## COMMUNITY BOARD NO. 2, MANHATTAN

February 3, 2023

- 1. Resolution providing CB2 comment as part of the initial public comment period for the Tier 1 Environmental Impact Study (“EIS”) and Tentatively Selected Plan (“TSP”) of the US Army Corps of Engineers (“USACE”) New York / New Jersey Harbors and Tributaries (“NYNJHAT”) Study.**

Fig. 3: SBM Large Floodwall Cross-Section

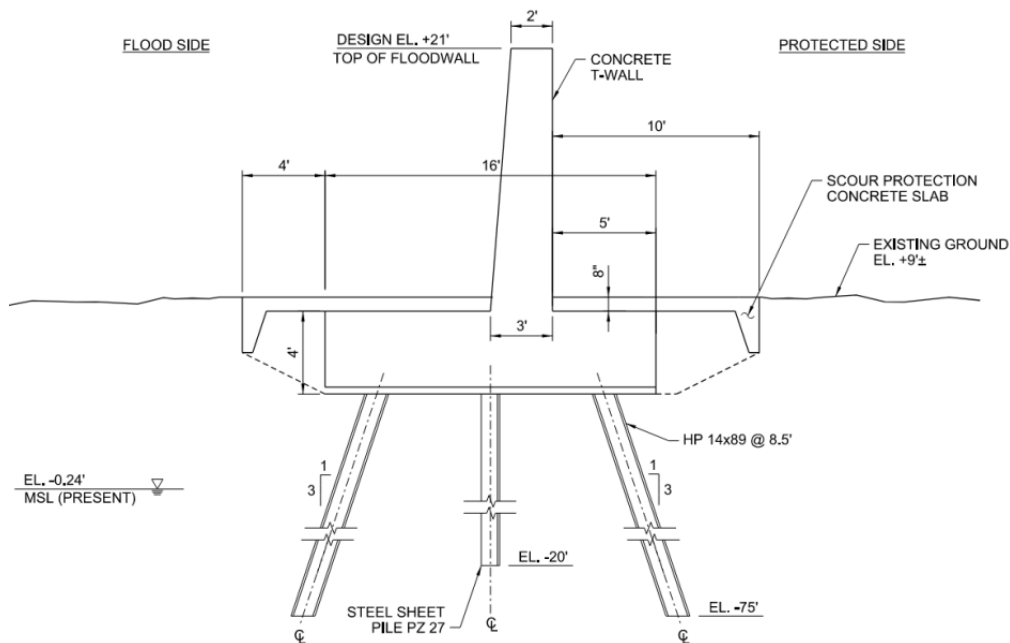
- 16. Whereas,** while CB2 understands that many aspects of the plan for SBMs along CD2’s waterfront are still in the early stages, it is clear that should the plan move forward as it is currently designed, it would have an unprecedented and substantial impact on the waterfront along the west side, with a 20+ foot floodwall completely transforming and re-defining the community and the public at large’s access to the waterfront (see Fig. 6 below for a rough rendition of such floodwall); and

- Clarification on how much of the design of the SBMs is open to modification and what the process for such modification would be
- Consideration of the significant amount of disruption that would occur to Hudson River Park and the waterfront on the west side should flood walls be constructed as currently proposed – given the narrow width of Hudson River Park in many areas, such construction would be highly disruptive to the park itself, to the bike lane and to the west side highway

- An overall consideration of the “cost” of the project – what is the cost of the severe impact to a valuable amenity like the Hudson River Park and the cost of cutting it off the shoreline from the community with a 20+ foot wall, both during and after the construction phase

Fig. 5 - Roller Gate (Deployable Barrier) Cross Section

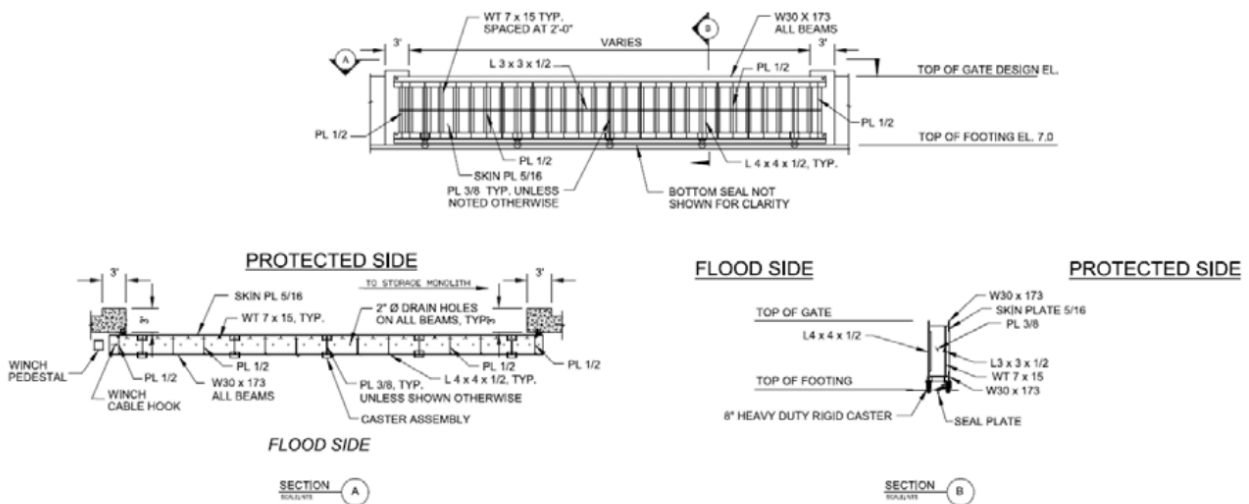
- Ensuring that green infrastructure is included where possible and relevant
- Considering alternatives to the “concrete wall” solution – including “flip-up” barriers (such as those being built currently in the two bridges area) and deployable barriers that could be stored offsite (in an area such as Pier 40) and brought into place ahead of a storm
- In addition to green infrastructure, consideration of other multi-benefit infrastructure that could be used - i.e. other benefits that can be leveraged from the investment other than direct storm surge protection
